Addendum No. 3 to the Environmental Impact Report on the
American River Watershed Common Features Project/
Natomas Post-authorization Change Report/
Natomas Levee Improvement Program,
Phase 4b Landside Improvements Project

State Clearinghouse No. 2009112025

Sacramento
Area Flood
Control
Agency

December 13, 2018

Figure 3-1. Reach H Construction Project Area

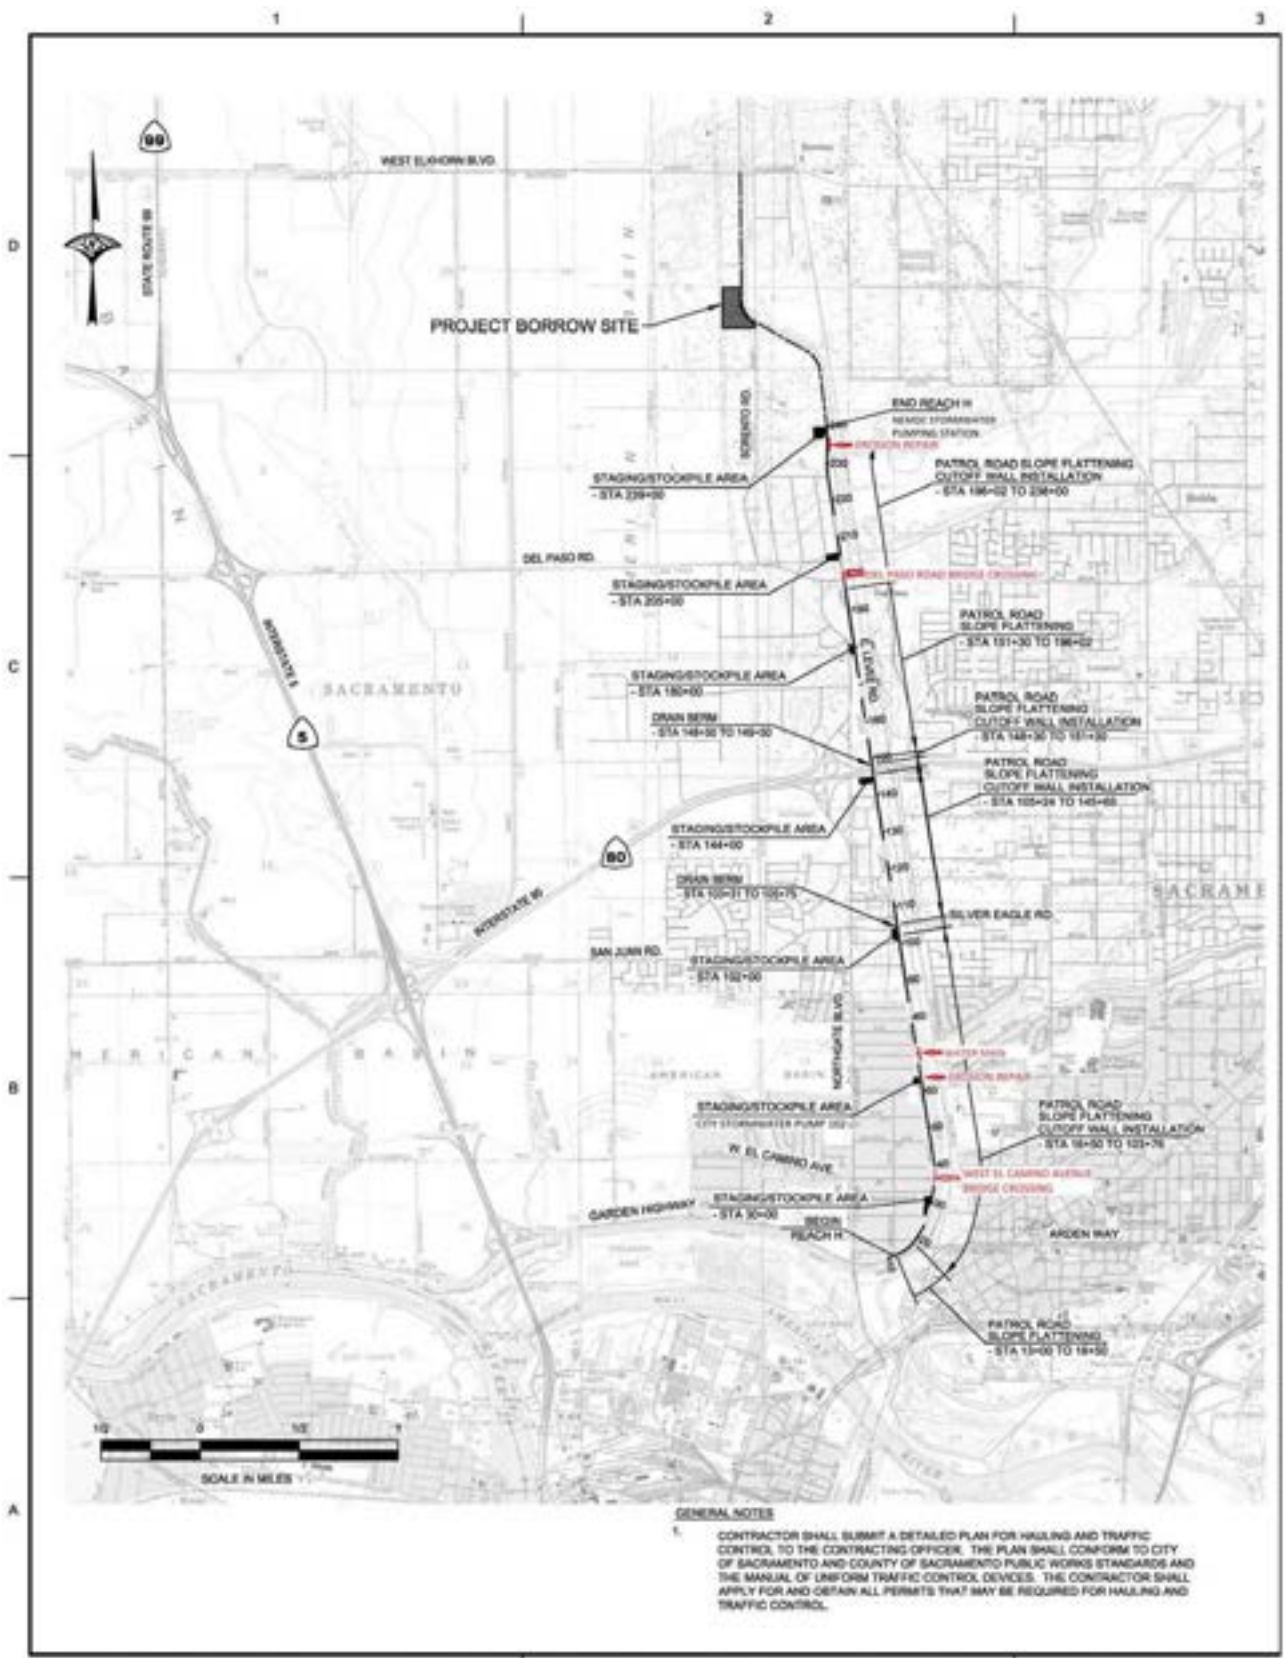
Reach H is located along the west side of the NEMDC from the intersection of Northgate Boulevard and the Arden-Garden Connector on the south to the NEMDC Stormwater Pumping Station on the north (Figure 3-1). Construction along Reach H would include the installation of a seepage cutoff wall through the majority of the reach. A landside stability berm would be constructed at the San Juan Road bridge crossing and a landside seepage berm would be constructed adjacent to the Interstate 80 (I-80) crossing.

Seven staging areas along the length of Reach H are being proposed (Figure 3-1). Staging areas would be located on the landside of the levee at intervals of 2,000–4,000 feet to minimize the distance required to pump the water-bentonite slurry mixture to the open cutoff wall trench. The staging areas would be accessed via Harding Avenue, Bowman Avenue, Rimmer Avenue, Rosin Court, Northgate Boulevard, Sotnip Road, and East Levee Road.

The use of the Krumenacher and Twin Rivers Unified School District borrow sites was fully analyzed in the 2010 Final EIS/EIR. Currently, only the Twin Rivers Unified School District site is being proposed as the borrow source for Reach H. This site is located northwest of the intersection of Sorento Road and East Levee Road, less than three-quarters of a mile north of the north end of Reach H (Figure 3-1).

Plate 10

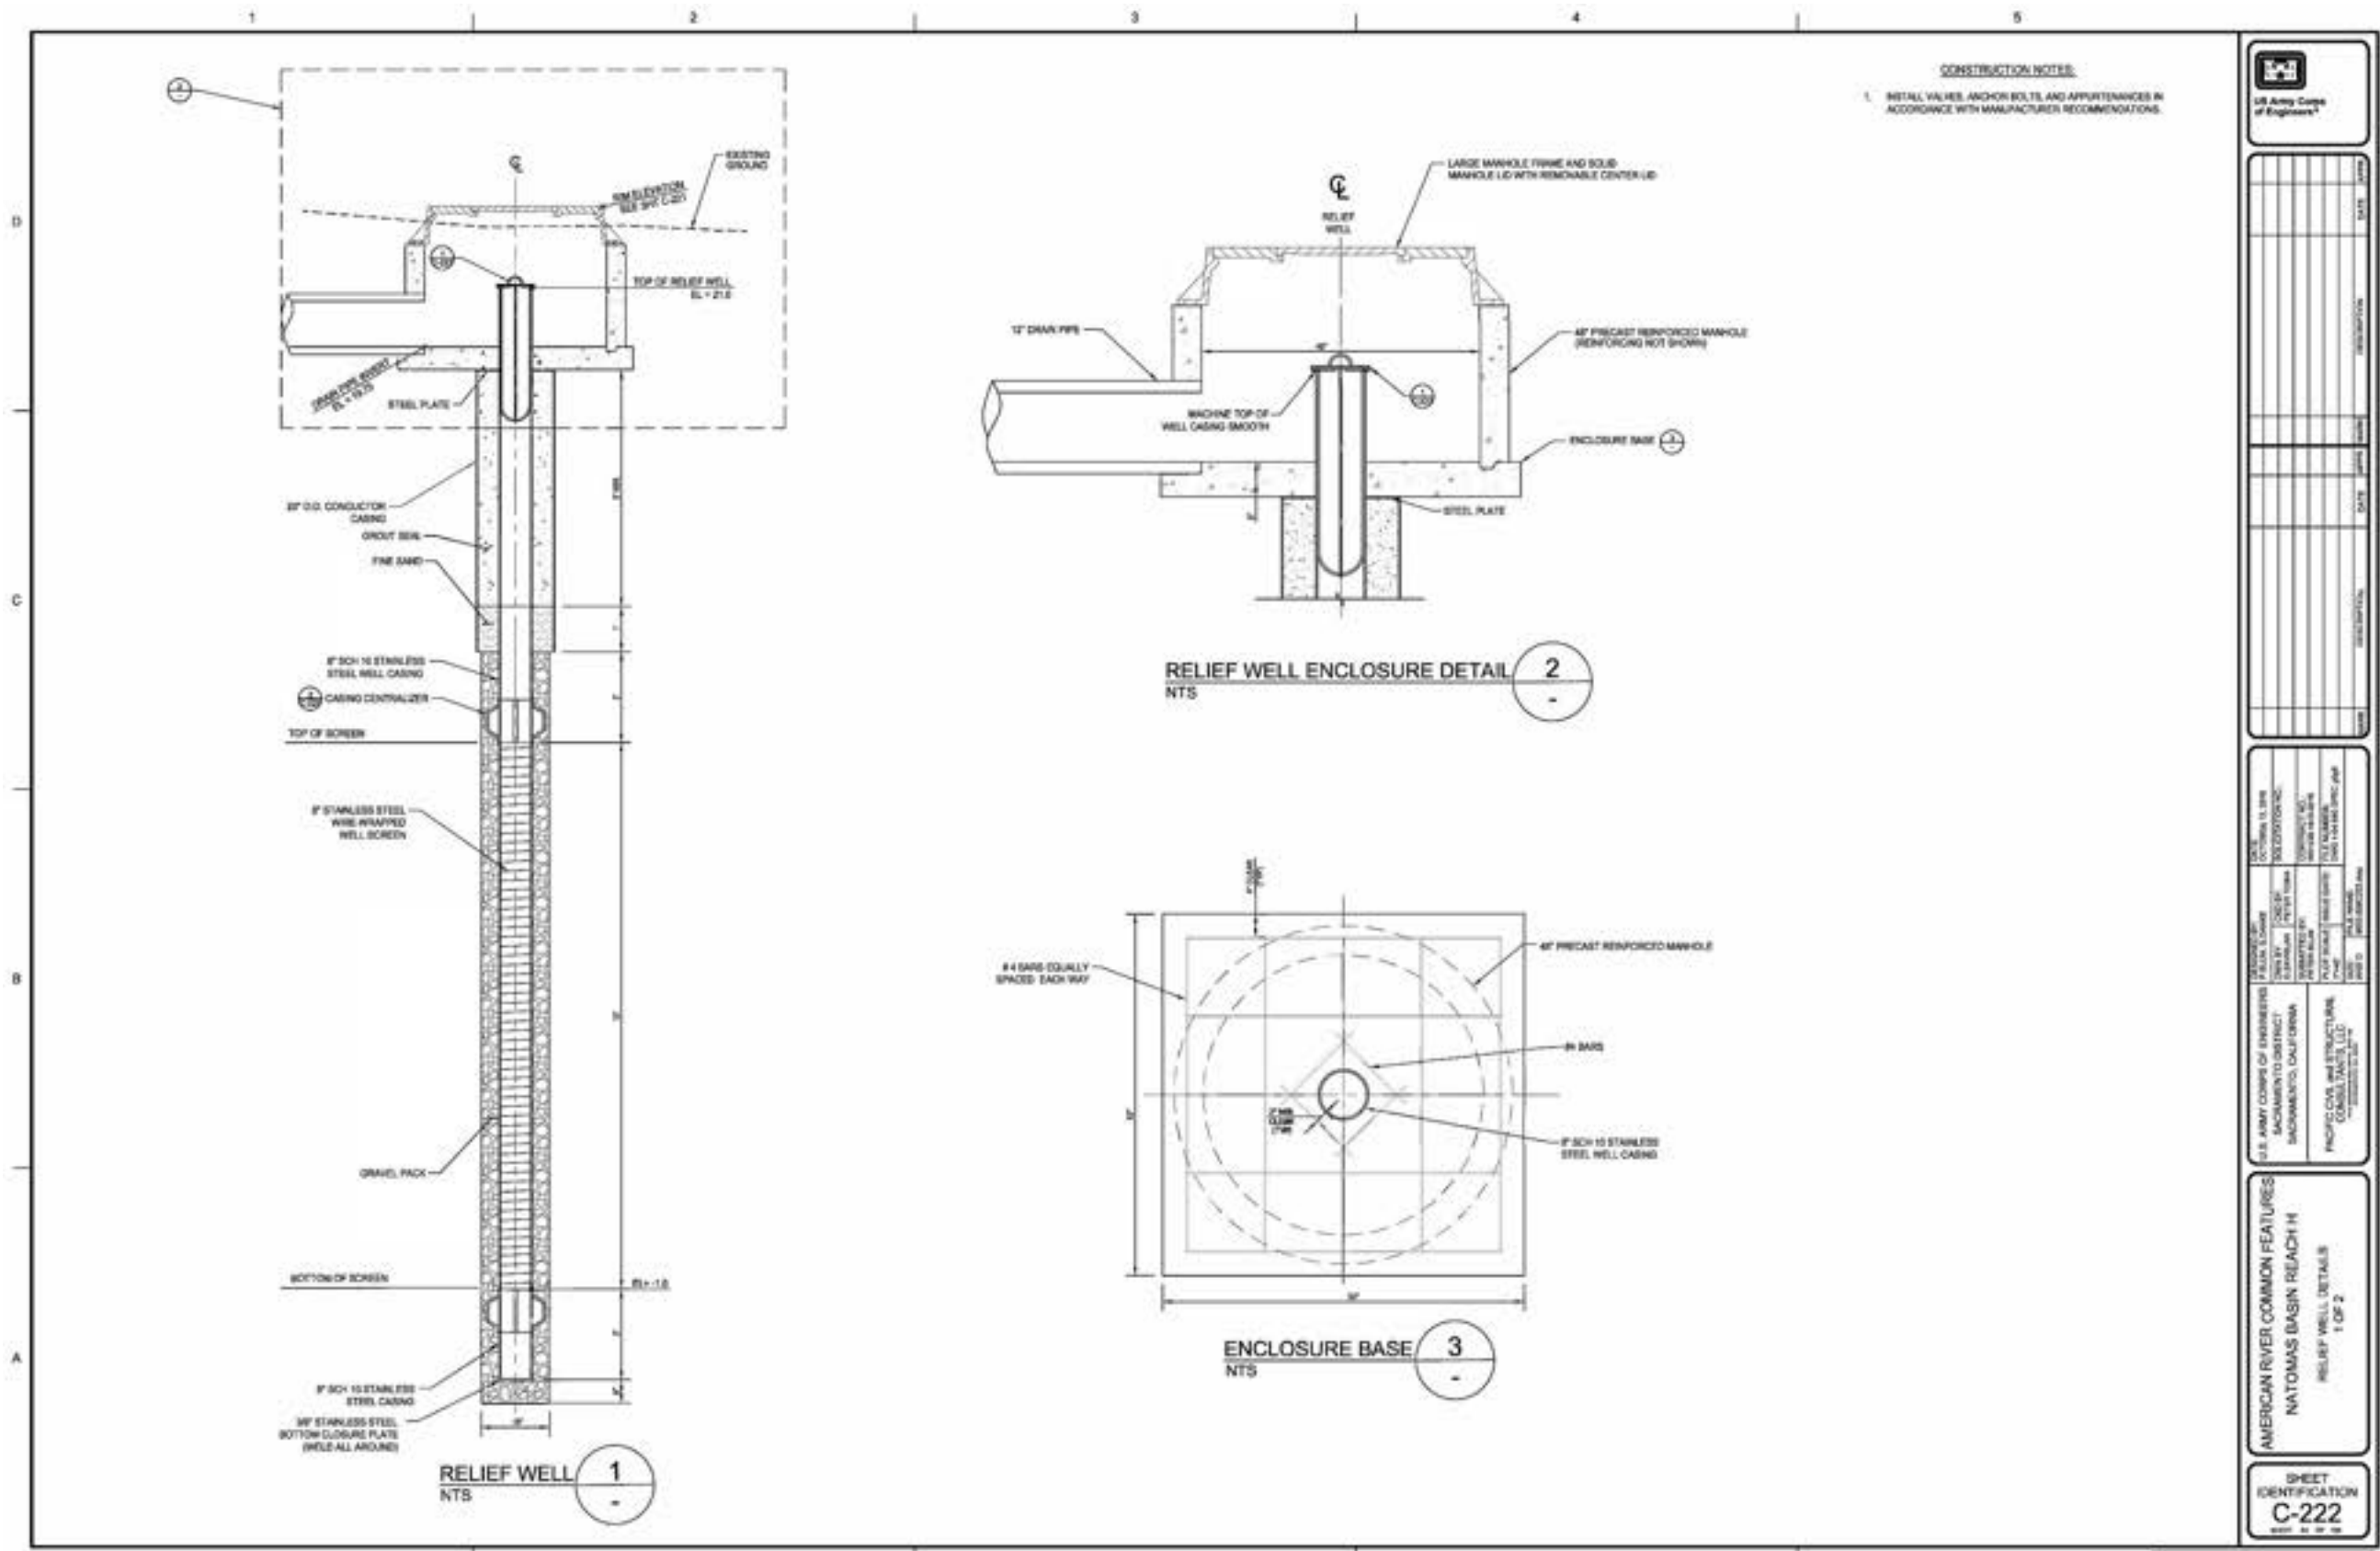
A PG&E gas main crosses the NEMDC west levee at Haggin Avenue. The SB cutoff wall would be discontinuous at this location and two relief wells would be constructed to meet seepage design criteria. Water from these relief wells would be discharged to the City of Sacramento stormwater drainage system. The relief wells would only operate and discharge water when surface water elevations in the NEMDC are above the ground surface at the landside toe of the levee causing surface water to be present. Plates 9 through 12 in Appendix A present current design drawings of the proposed relief wells.
